**RE: Mister Car Wash - 98th St. & Volcano Rd.
Grading and Drainage Plan & Drainage Report
Engineer's Stamp Date: 03/27/19
Hydrology File: K08D004**

DRAINAGE AND TRANSPORTATION INFORMATION SHEET (REV 6/2018)

**RE: MISTER CAR WASH – 98TH AND VOLCANO
GRADING AND DRAINAGE PLAN RESPONSE TO COMMENTS
ENGINEER'S STAMP DATE**

<p>RONALD R. BOHANNAN P.E. #7868</p>	MISTER CAR WASH 98TH ST & VOLCANO RD GRADING AND DRAINAGE PLAN	DRAWN BY DY DATE 3/27/19 2018058-GR-20
	 TIERRA WEST, LLC 5571 MIDWAY PARK PLACE NE ALBUQUERQUE, NM 87109 (505) 858-3100 www.tierrawestllc.com	SHEET # C2 JOB # 2018058

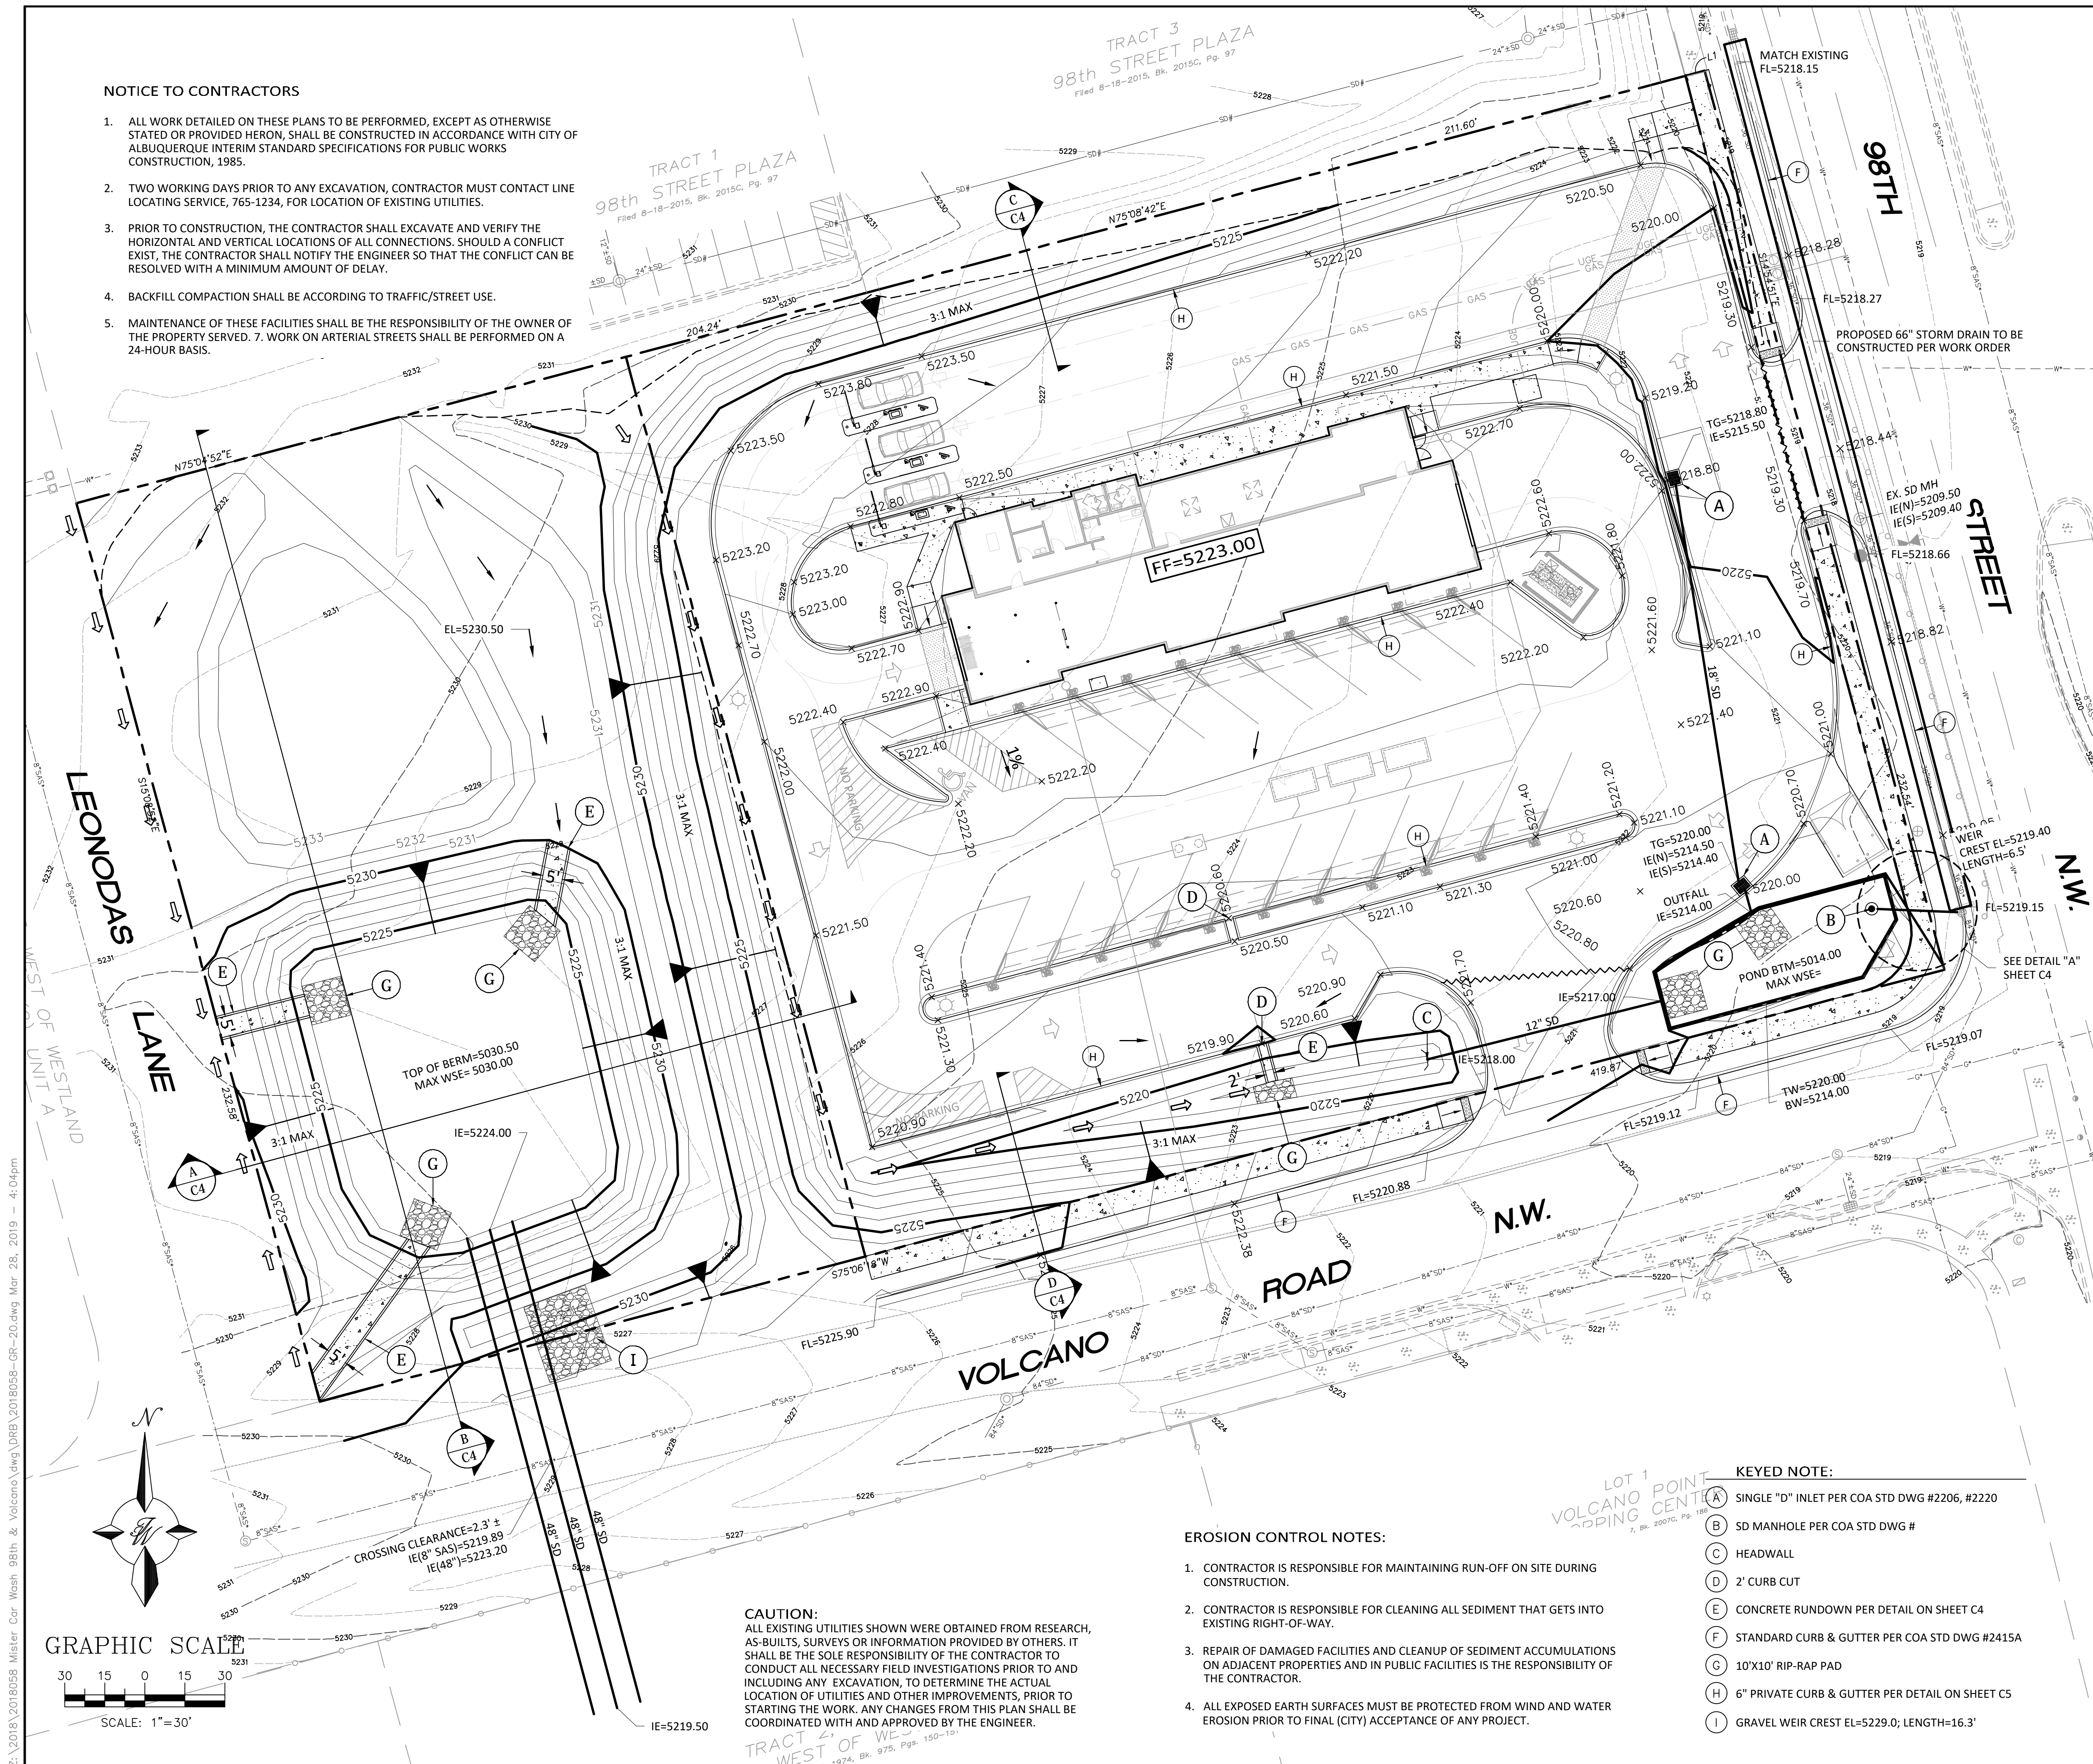
7. Sheet C2. Please either show a swale or revise grades to direct the flows from the off-site basin to Leonidas Lane.
Response: The correction has been made.
8. Sheet C2. Please show the proposed 66 inch storm pipe along 98th St. and add a label stating. "To be constructed with work order."

9. Sheet C2. Please add the flowline elevations along the prop curb on both 98th St. & Volcano Rd.

10. Sheet C2. Please enlarge the area of the stormwater quality pond and remove the proposed contours so that the proposed retaining wall will be shown.

11. Sheet C2. Please add the top of pond and bottom of pond for the City's detention pond.

Response: The changes have been made.

Response: The changes have been made.

Response: The changes have been made.

Response: The elevations have been added.

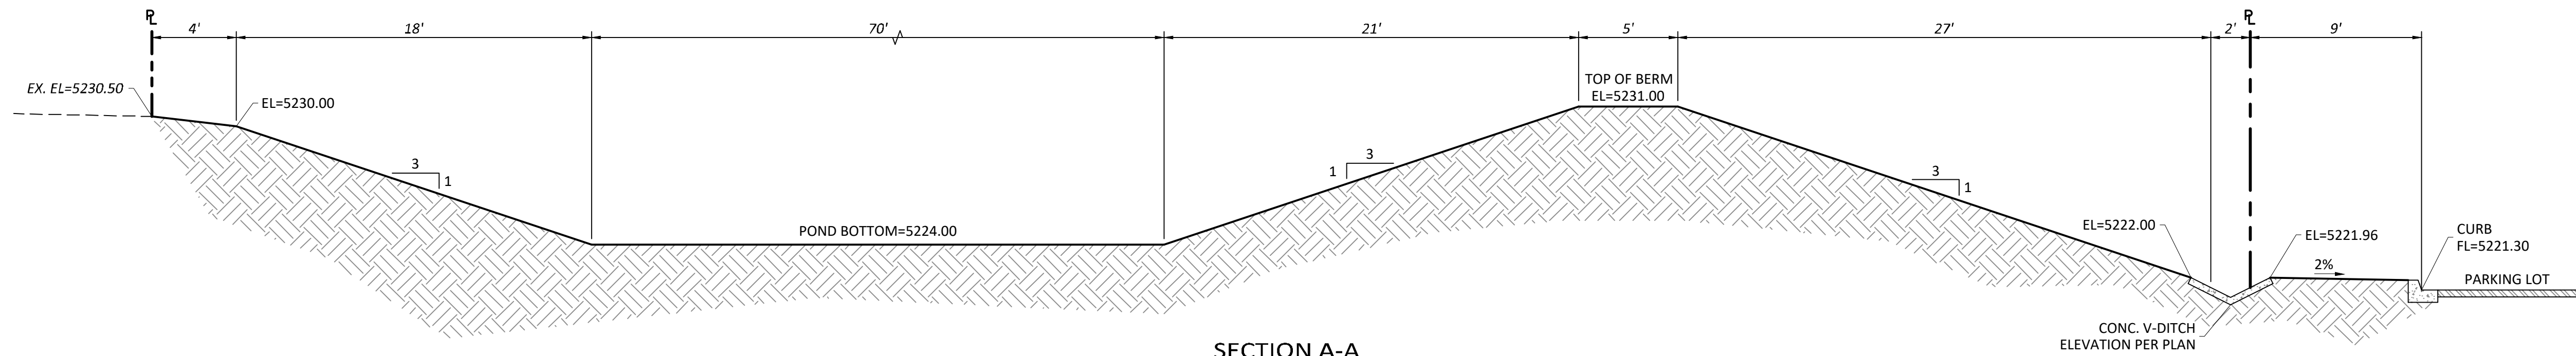
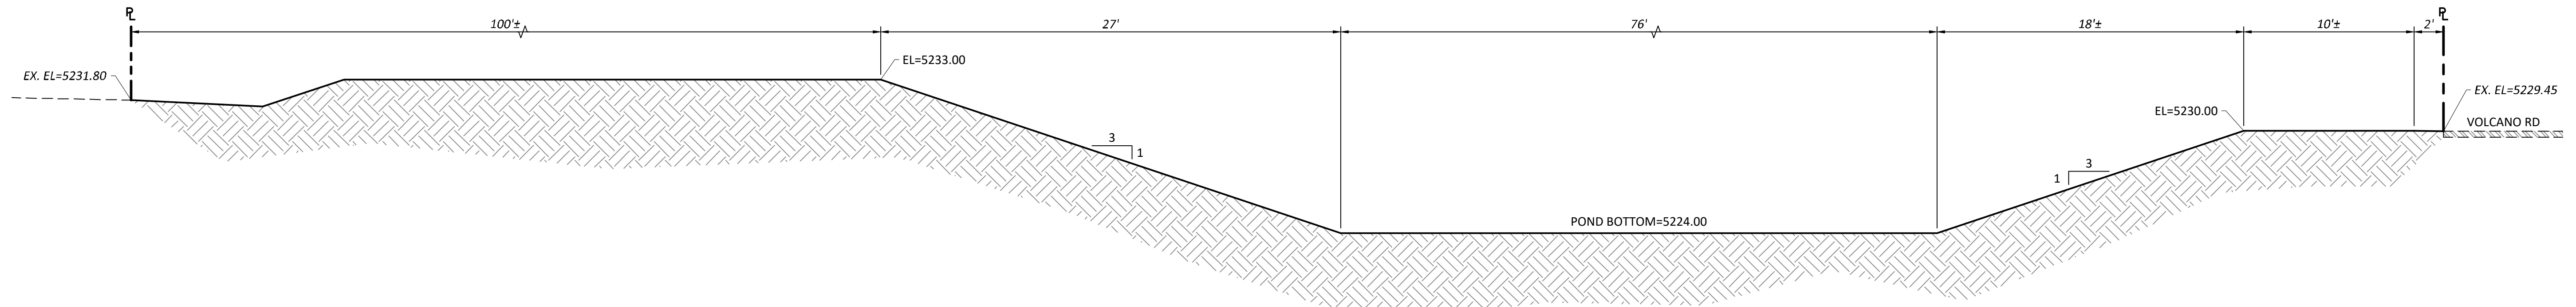
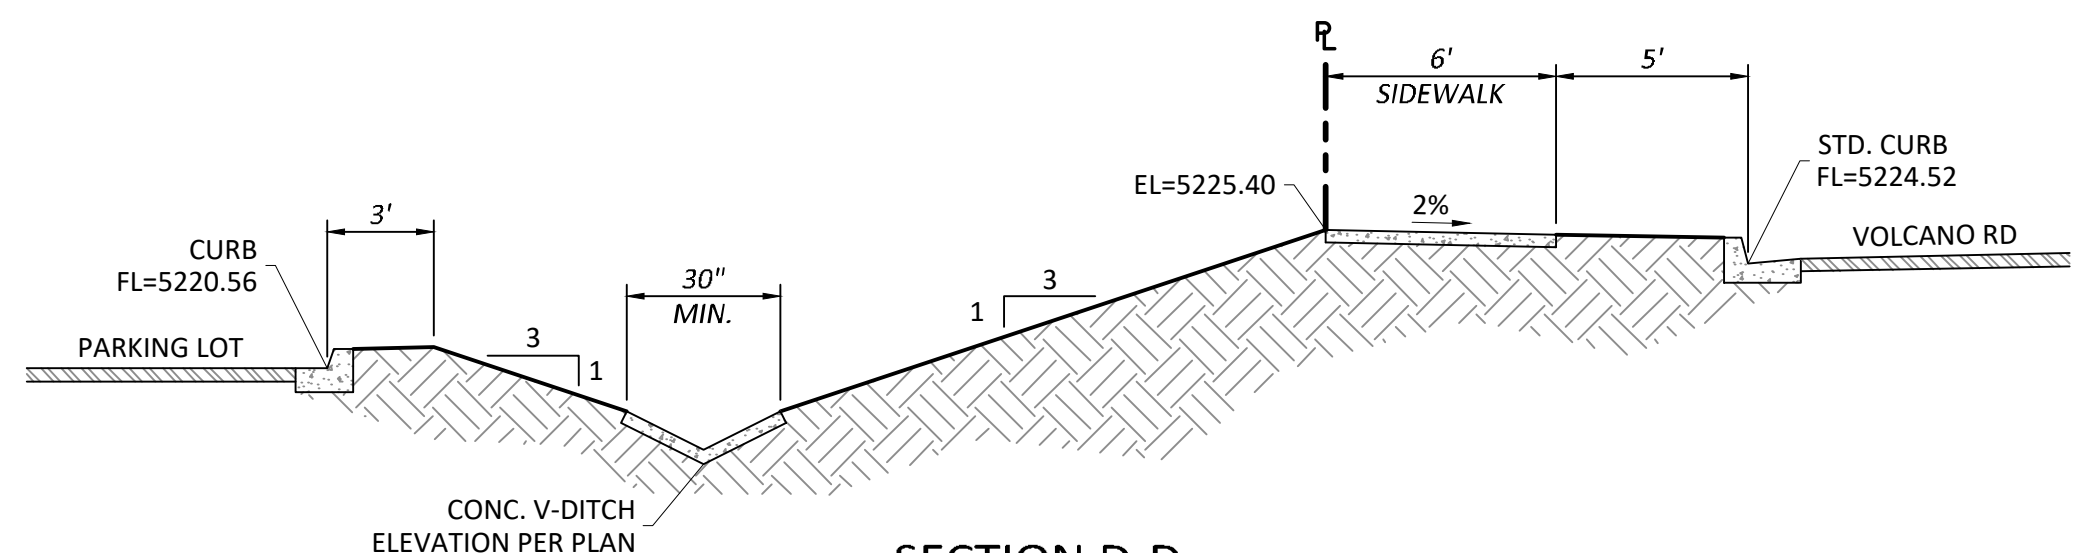
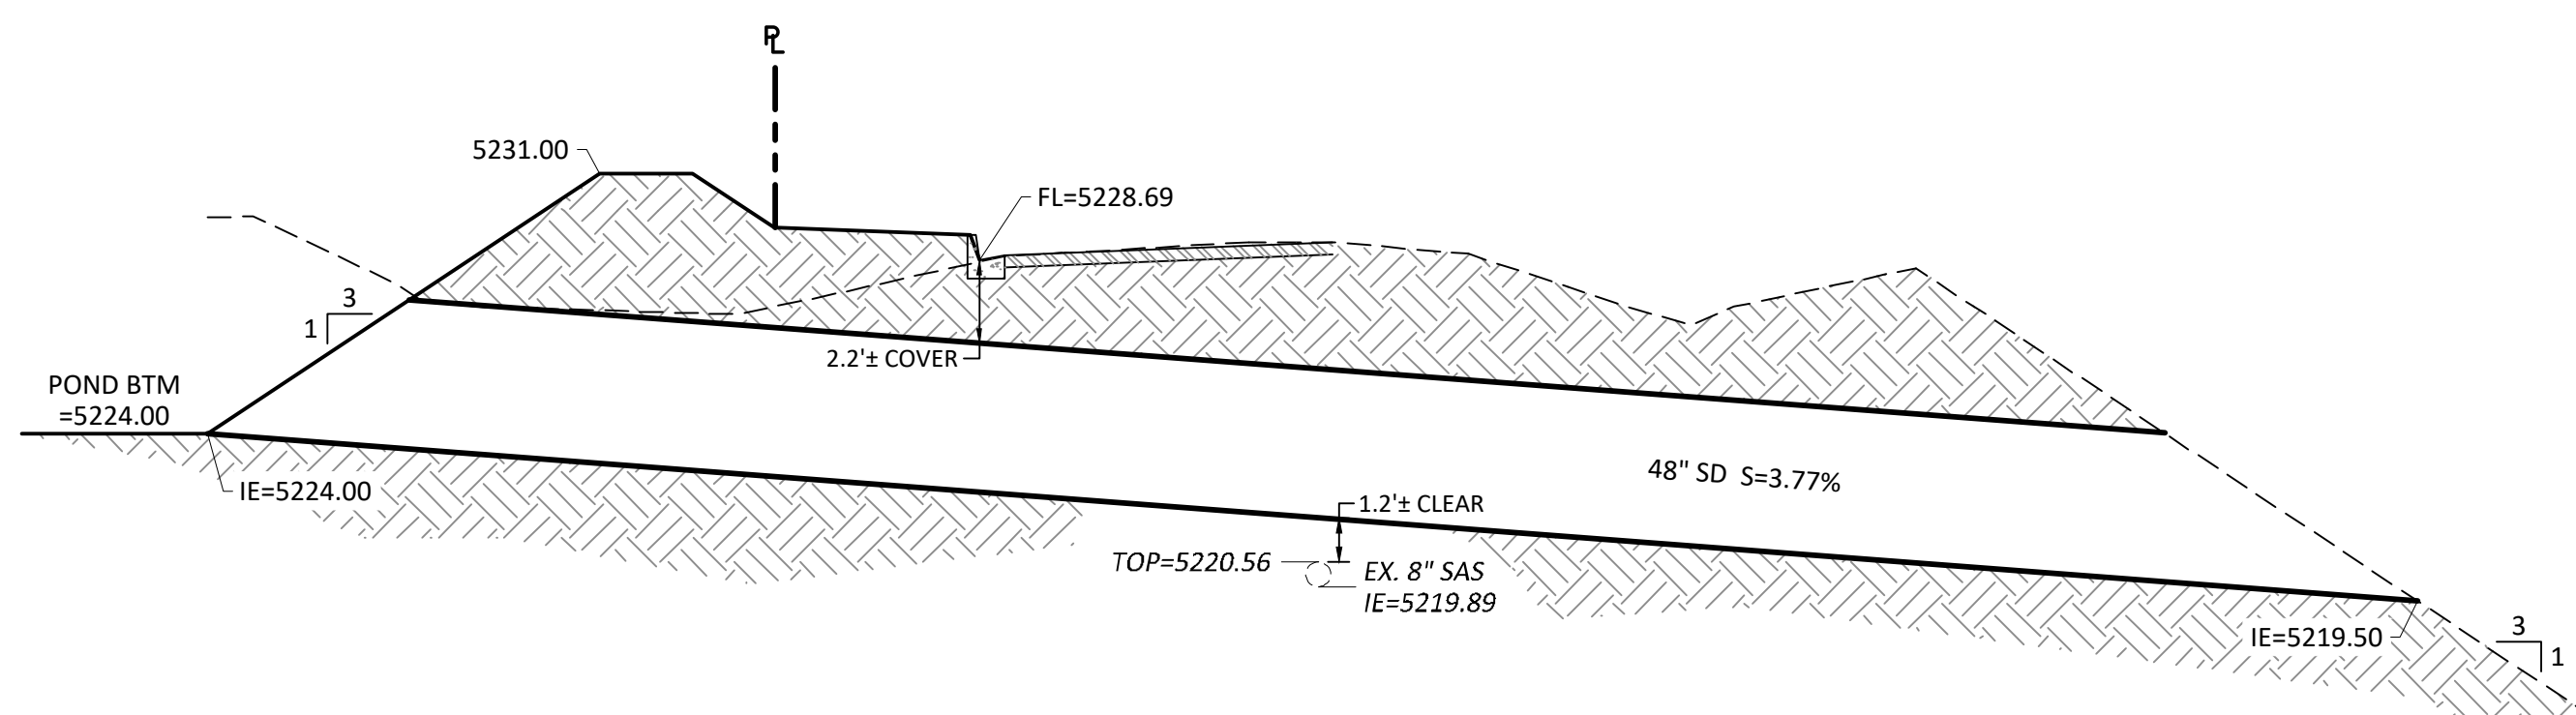
12. Sheet C4. Please add a section showing the 48 inch culverts, temporary pond, Volcano Rd curb & sidewalk, the existing City Pond, and the existing 8" sanitary sewer. Also add the clearance for the sanitary sewer and the top of the storm pipe.

Response: The detail has been added to sheet C4.

DETAIL "A"
NTS

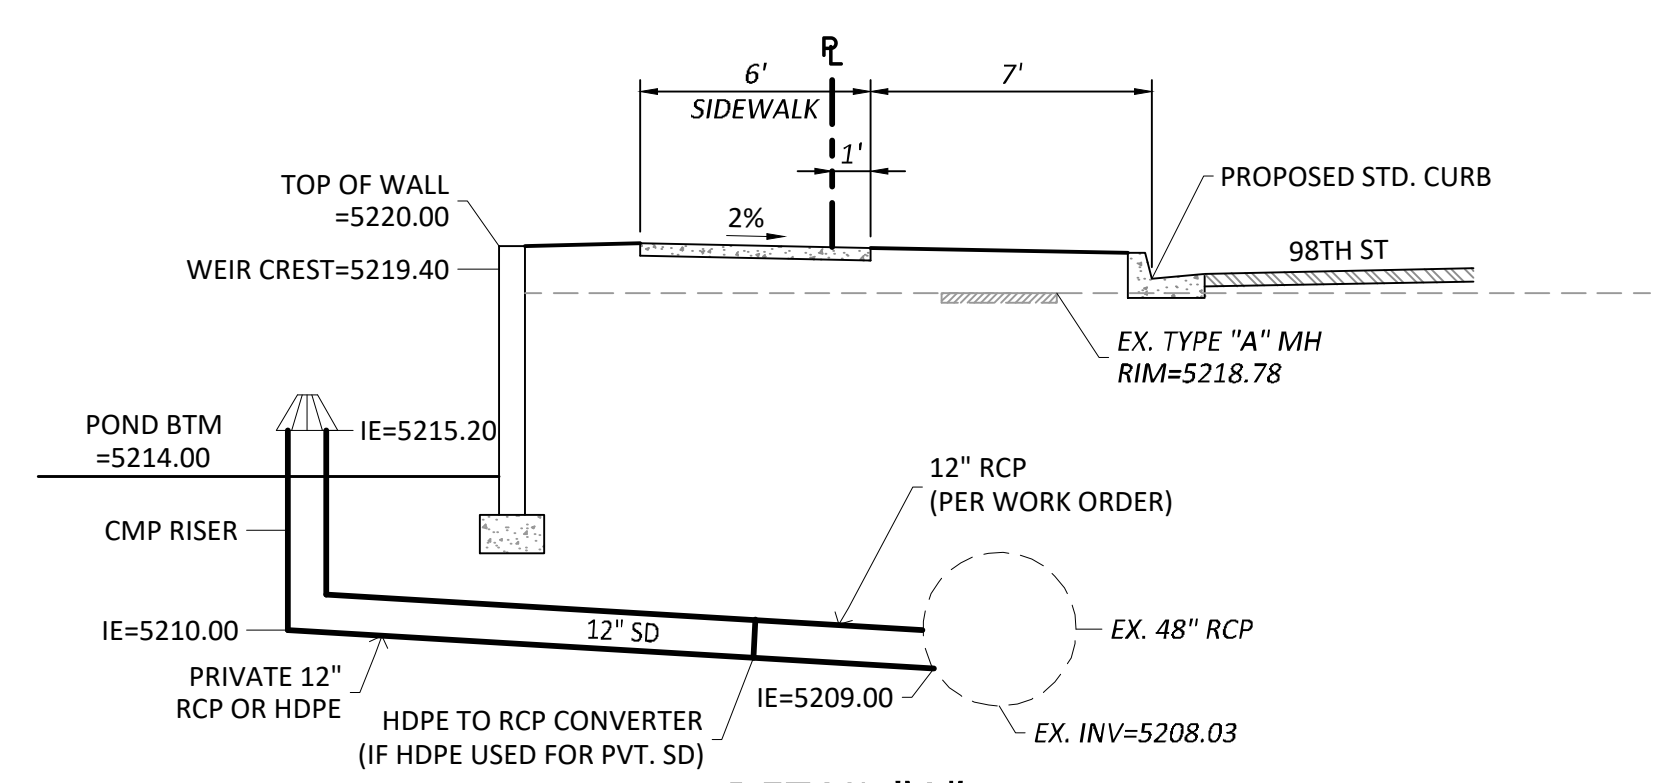
13. Sheet C4 – Detail "A". Either change the pipe from HDPE to RCP or add a converter from HDPE to RCP at the R.O.W. and add the detail from ADS.

Response: The detail has been added.
